Staff Report

Re: PLNPCM2020-00830 – *Detached Accessory Dwelling Unit*

Conditional Use

PROPERTY ADDRESS: 1792 S 2100 E
PARCEL ID: 16-15-308-020-0000
MASTER PLAN: Sugar House – Low Density Residential
ZONING DISTRICT: R-1/7,000 Single-Family Residential

SITE PLAN

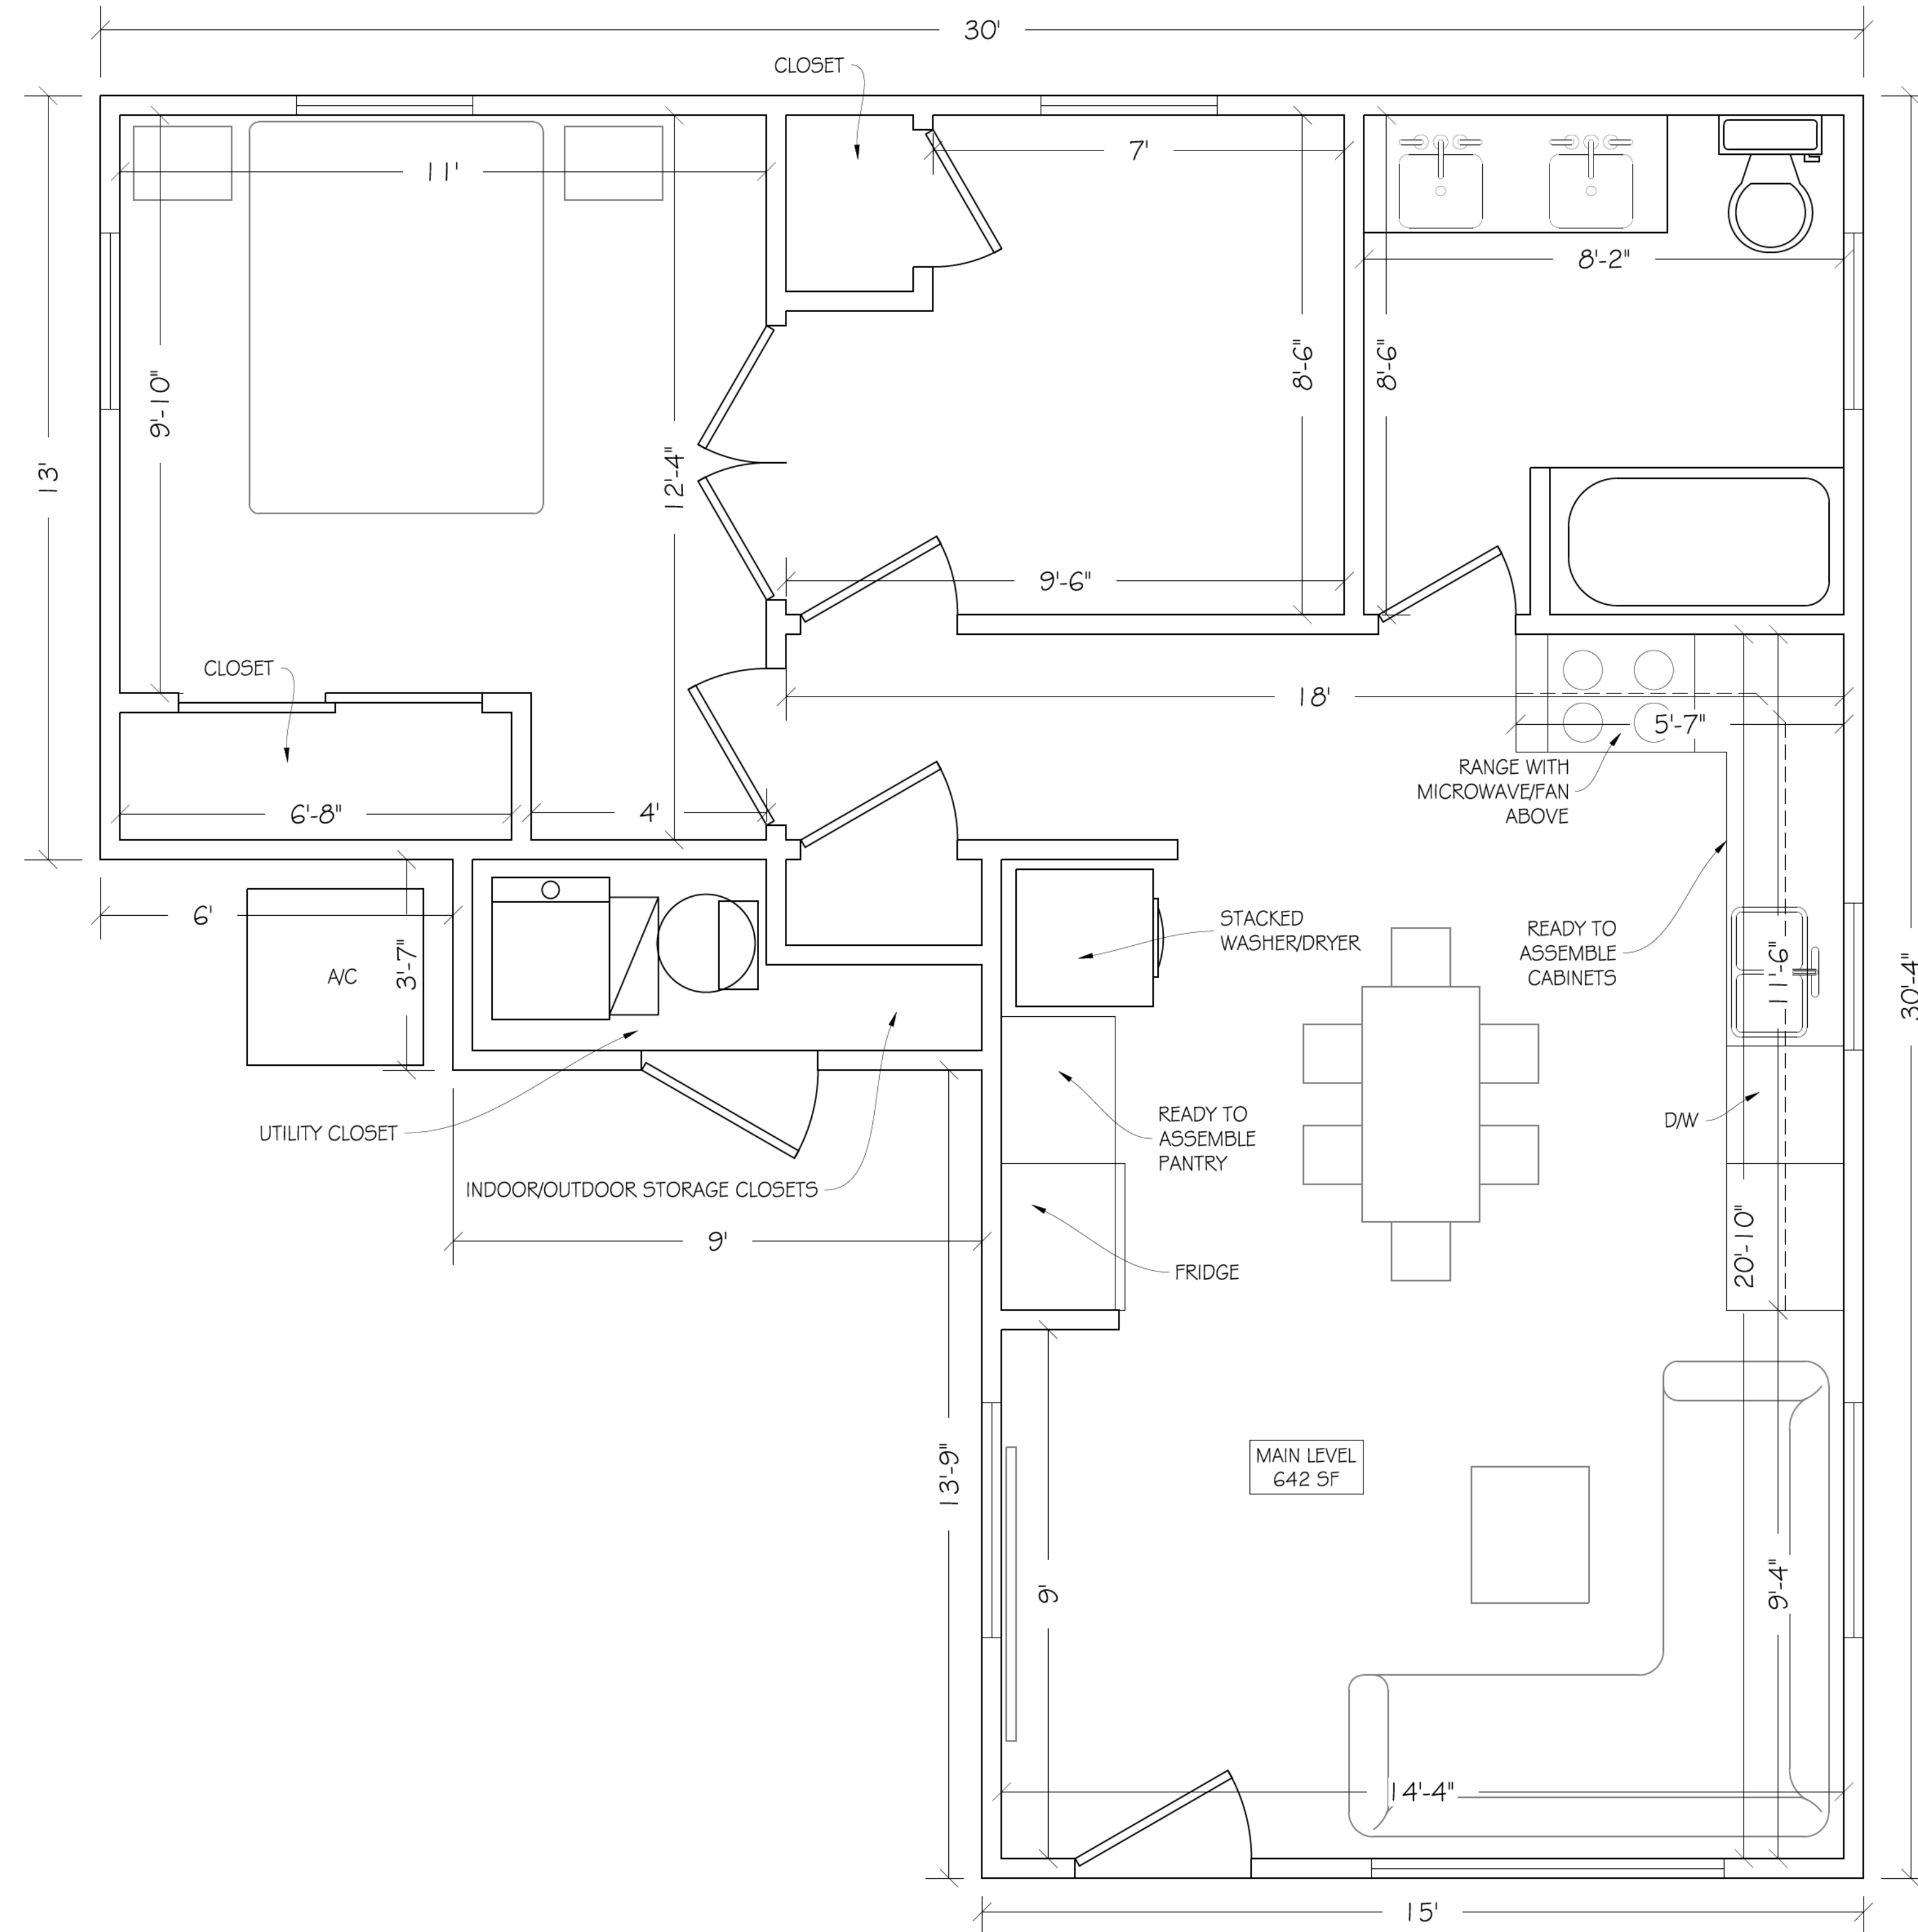
Planning response: setbacks are shown. They are 5' and meet the requirement.

Planning response: AC unit shown on site plan.

ELEVATIONS

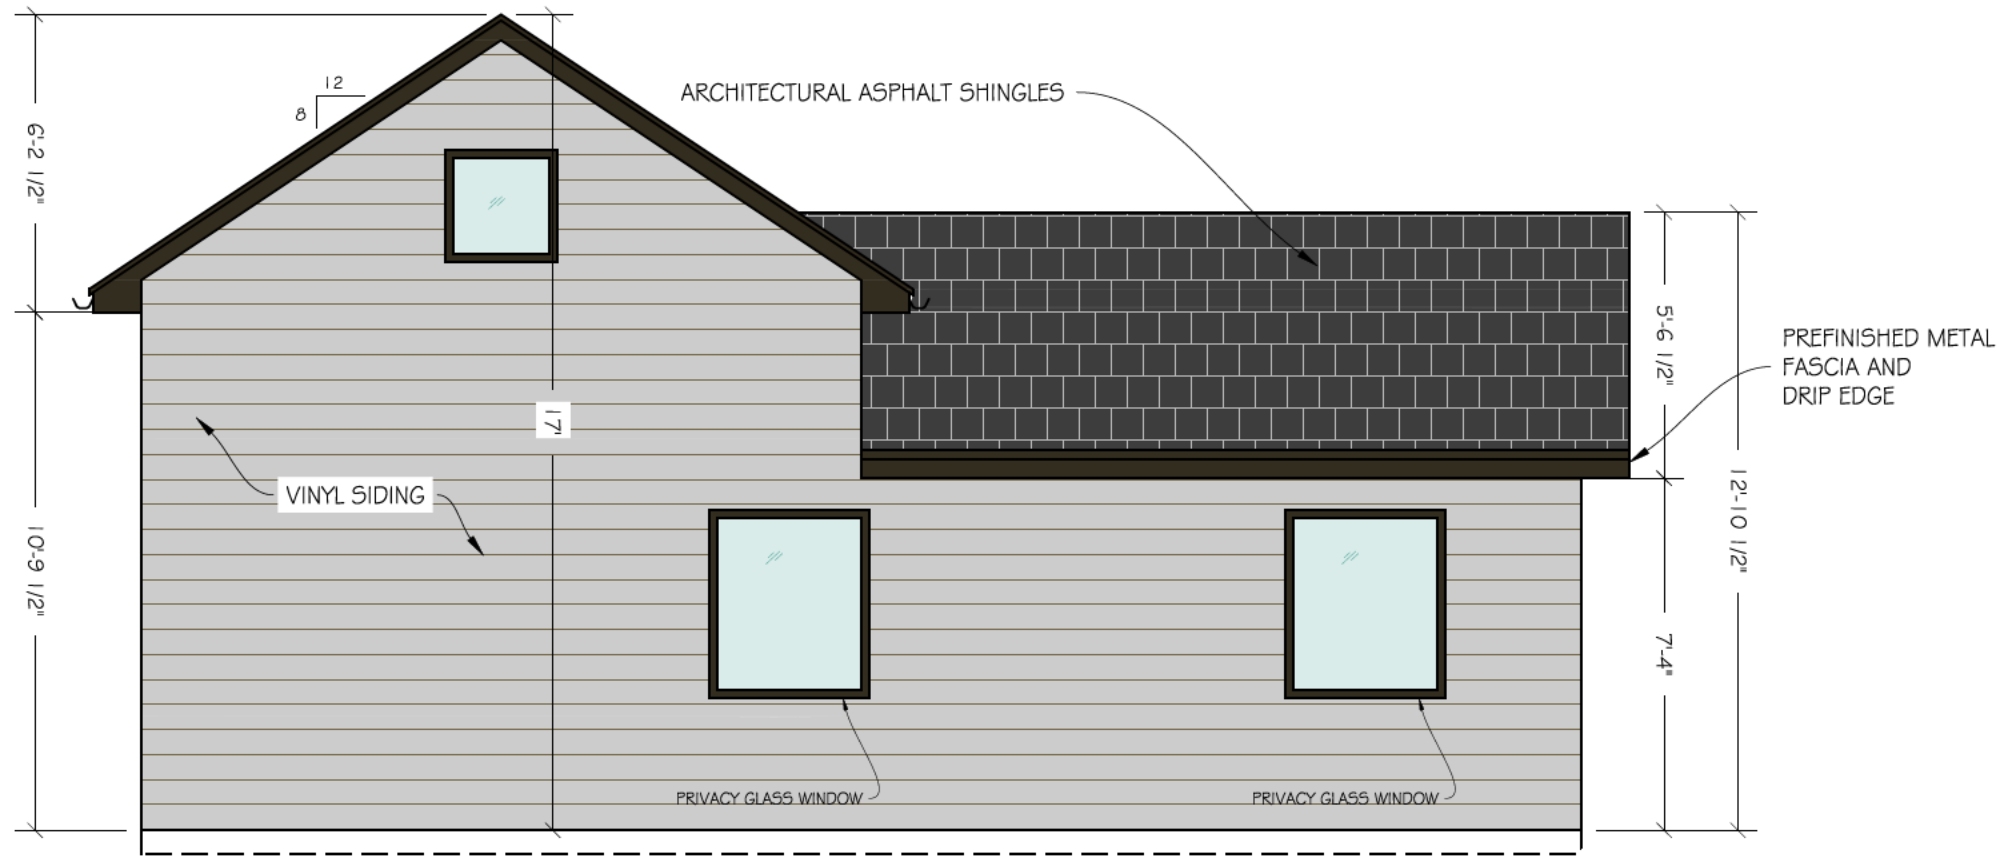
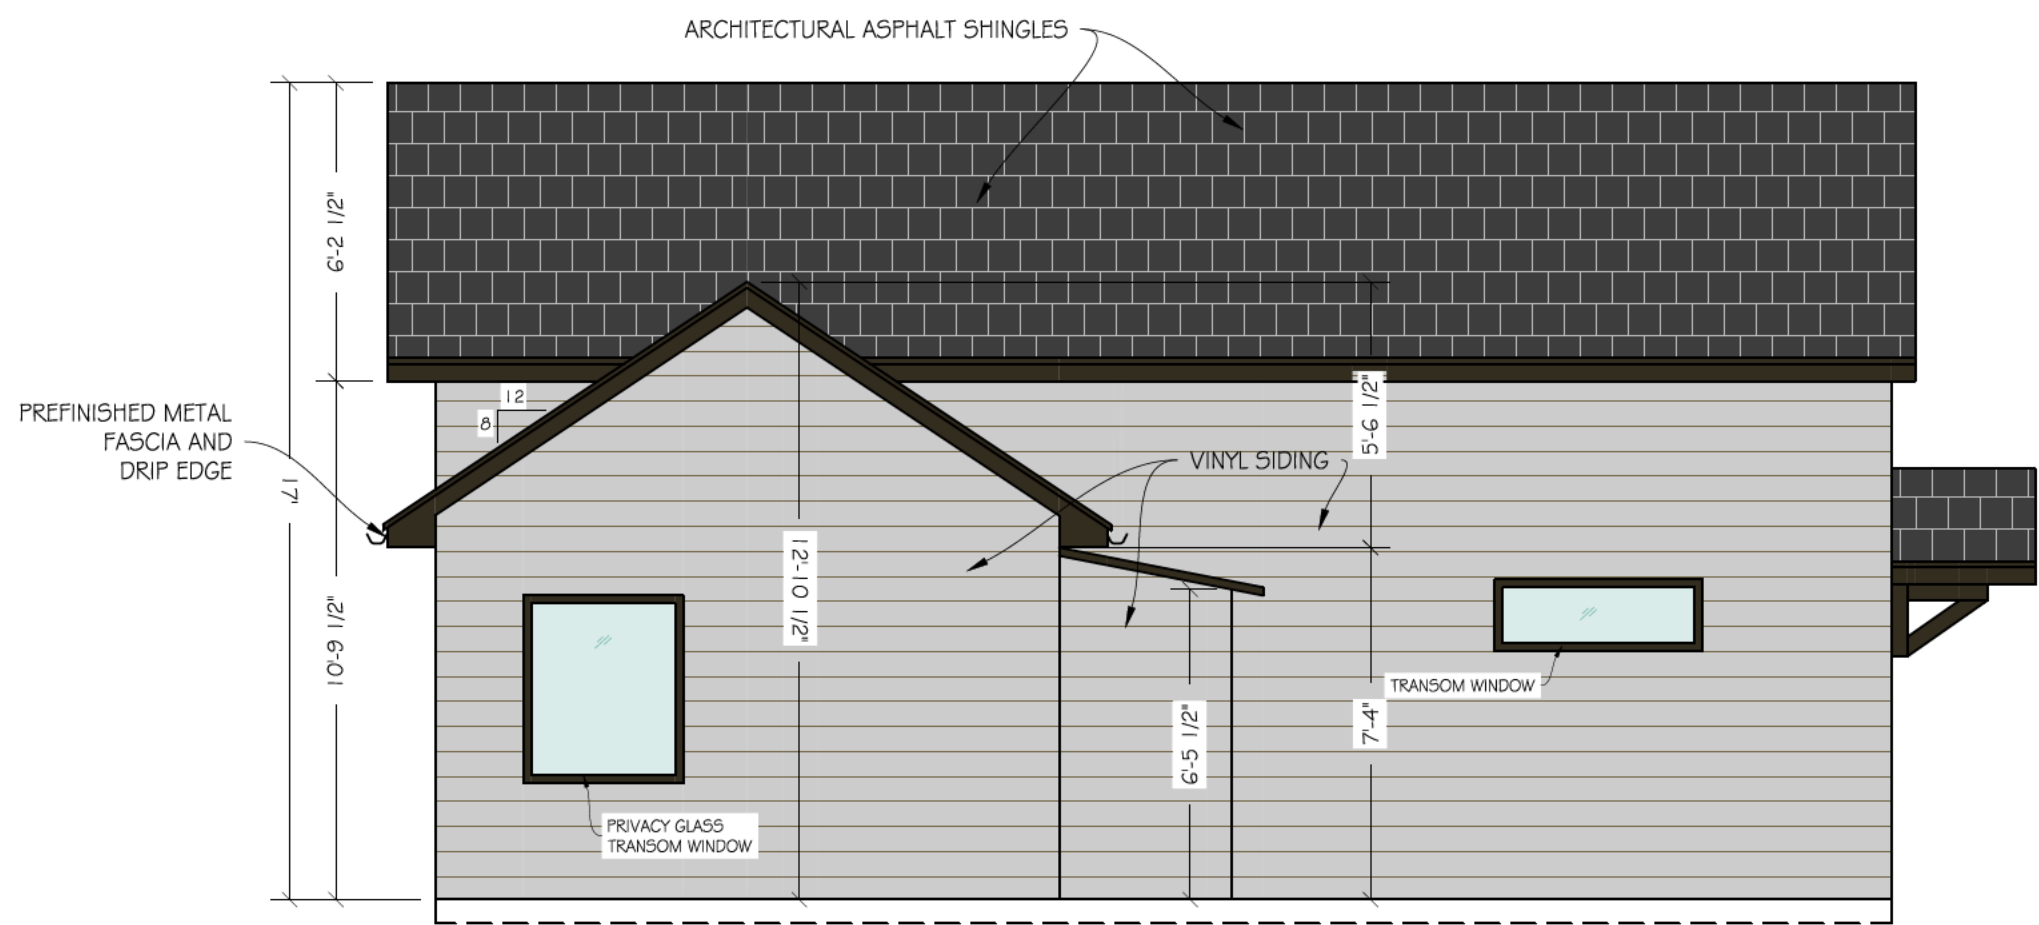
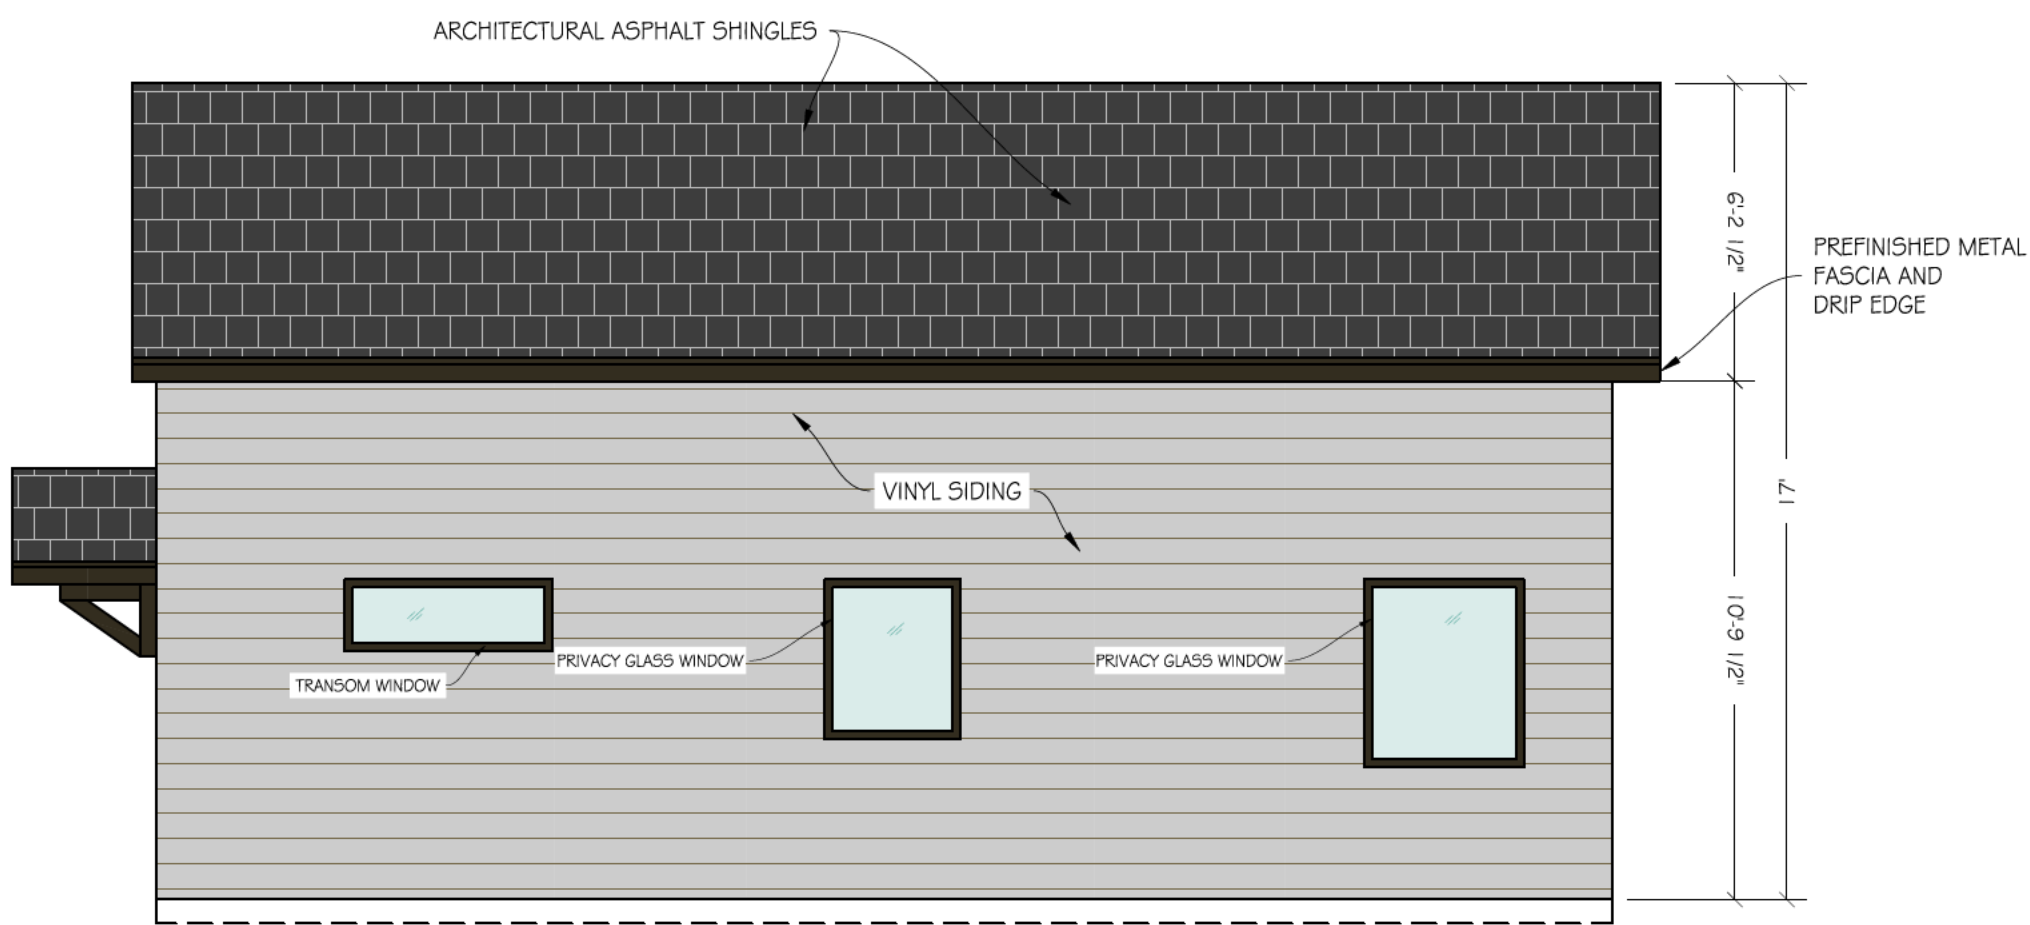
Planning response to applicant: Windows were revised and will be glazed to comply.

5. Need an elevation drawing of the ADU and the main dwelling. The height of the ADU may not exceed 17' – 24' or be taller than the main dwelling on the property.

Planning Response: Elevation was provided on page 3 of the plan set. ADU meets requirement of 17'.
